CONTENTS OF
LUMINARY IE

MIT/CSDL SOFTWARE DEVELOPMENT PLAN
FOR
LUMINARY 1E LGC PROGRAM

PROGRAM CHANGE REQUEST/NOTICE STATUS

Angular Error in Lunar Position from LOSSEM

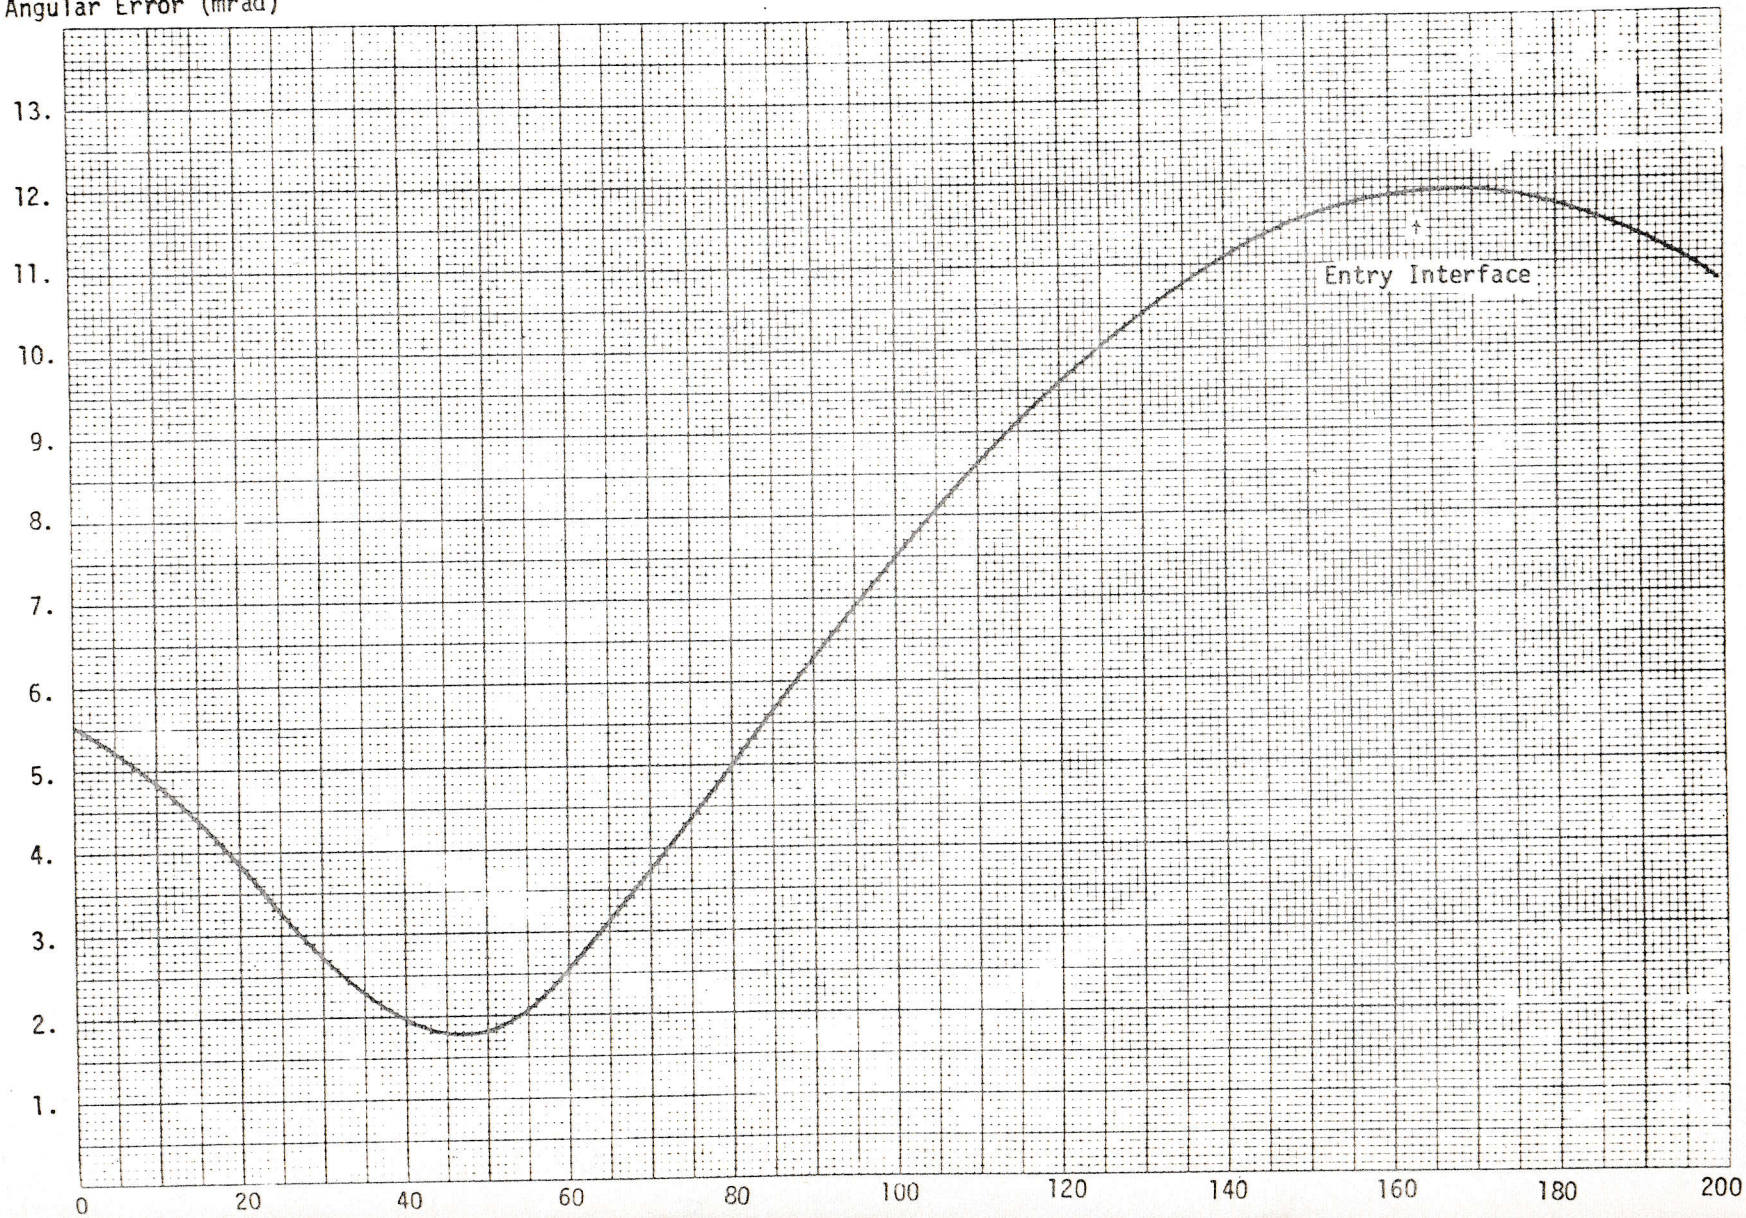
The attached graphs show the angle between the LOSSEM computed unit vectors and the true unit vectors. Note that time on both graphs is given in hours from midnight GMT prior to the launch. Launch occurred shortly after 19 hours GMT, April 11, 1970. The angular error for the earth-moon vector at entry interface was 11.82 mrad. The angular error at 6 hours prior to entry interface was 11.71 mrad. The angular error for the earth-sun vector near entry interface is 0.26 mrad with a random variation of 0. to 0.02 mrad. The smooth curve shown is the limits of the variation. The line segments shown are straight line connections of discrete data points and are only included for illustration.

PCR # 340

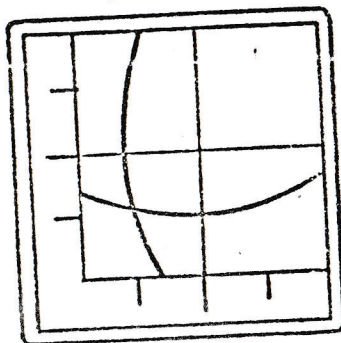
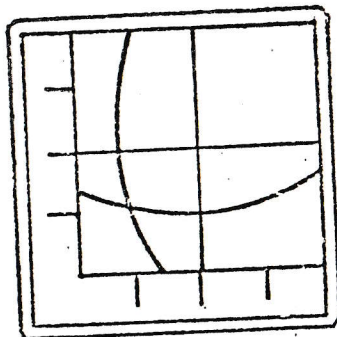
CONTROLLER
OPERATION TO NULL

PITCH DN
ROLL RIGHT

PITCH DN
ROLL LEFT

Figure 1

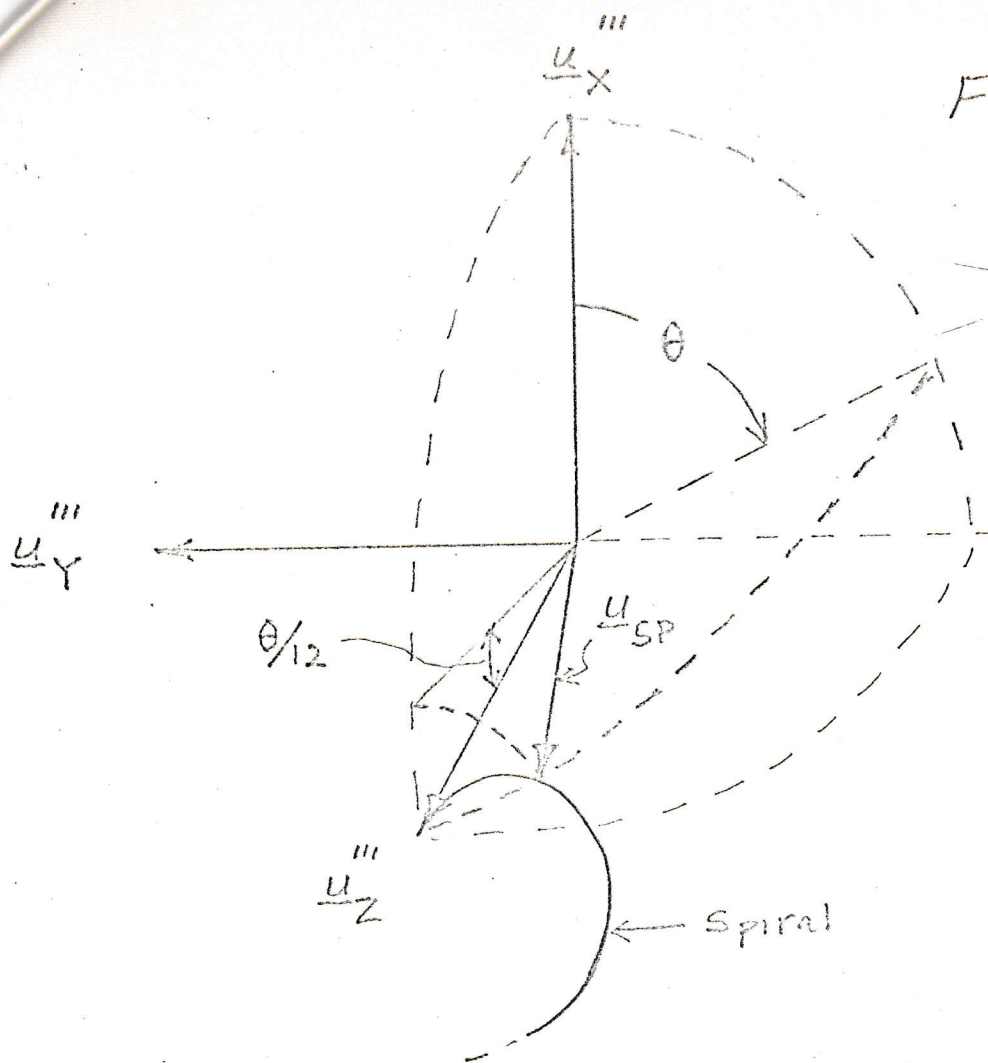
To mathematically express the spiral surface in a form convenient to the language of the LGC, use is made of a unit vector \underline{u}_{SP} which sweeps along the spiral as a function of the angle θ as shown in Figure 1.

In the triple primed coordinate system of Figure 1 the vector \underline{u}_{SP} can be expressed in terms of θ as:

FIGURE 2

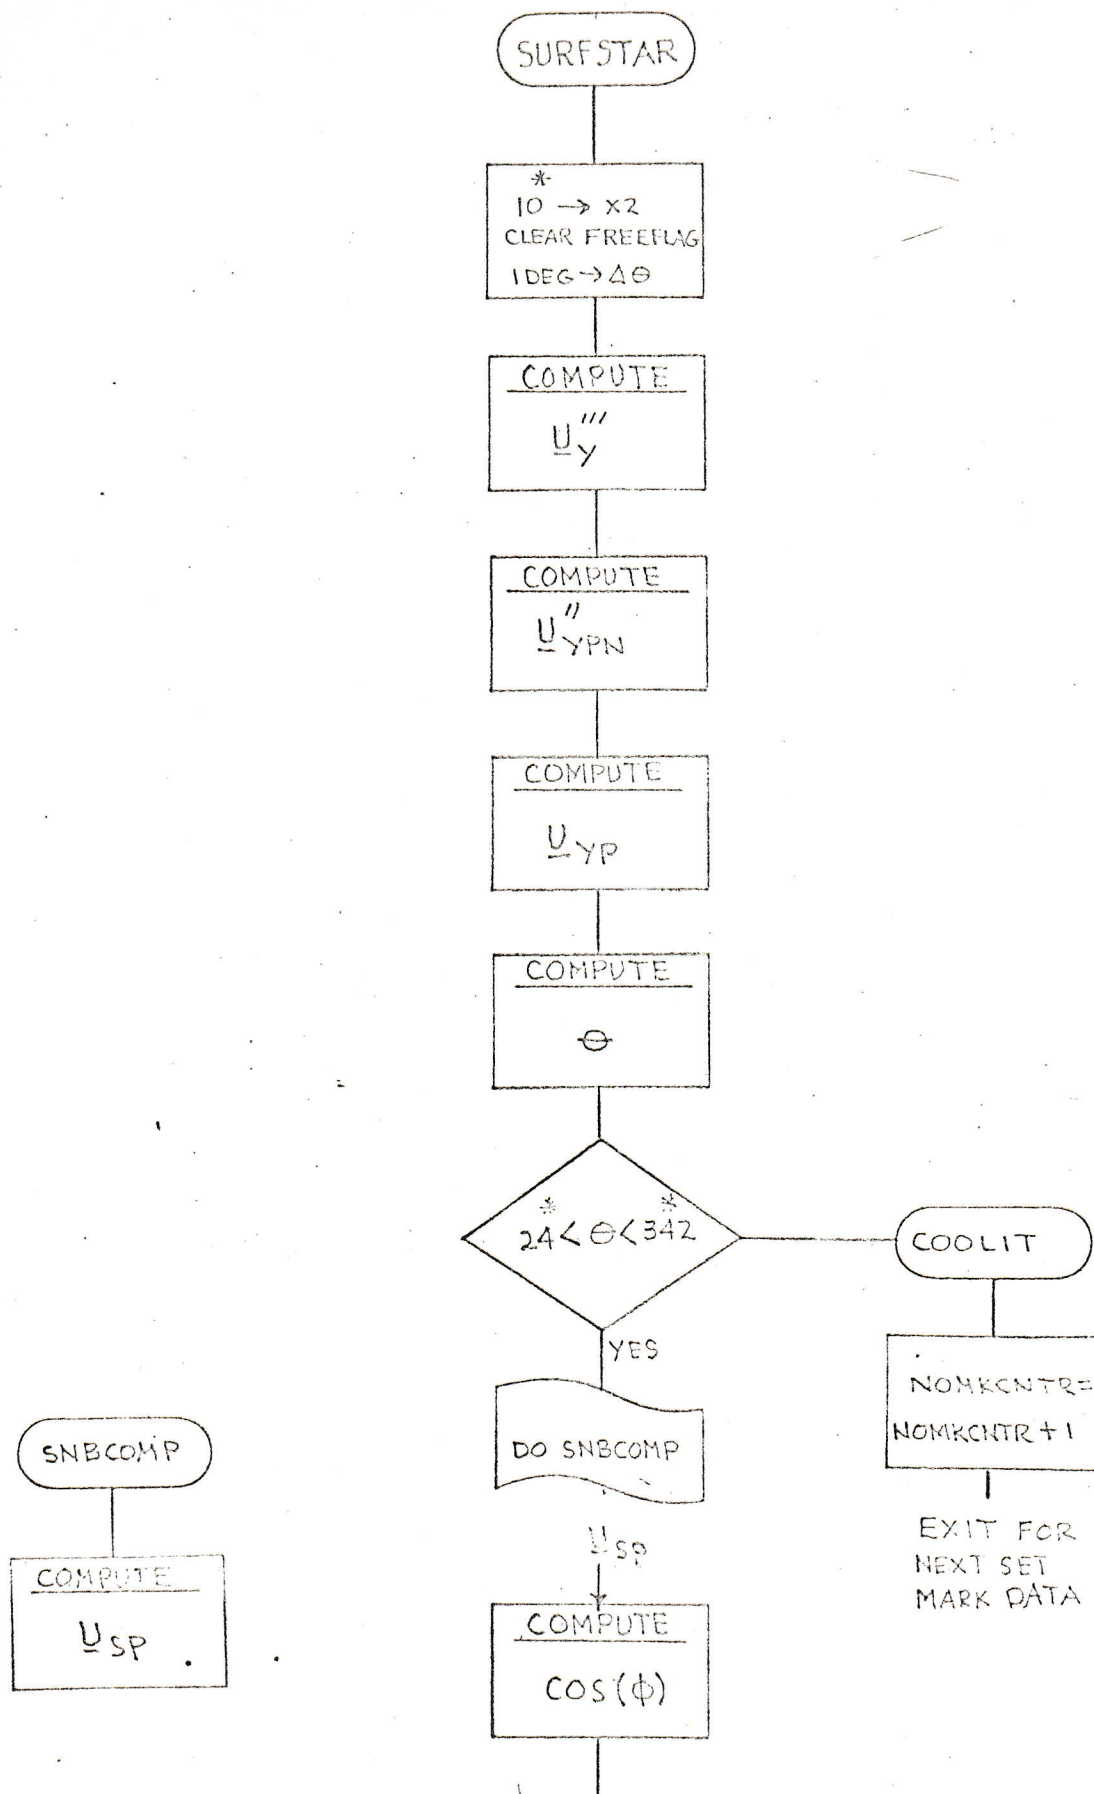
This is accomplished by the iteration loop in Figure 2 where the initial value of $\underline{u}_{\text{SP}}$ is based on an initial guess for θ of
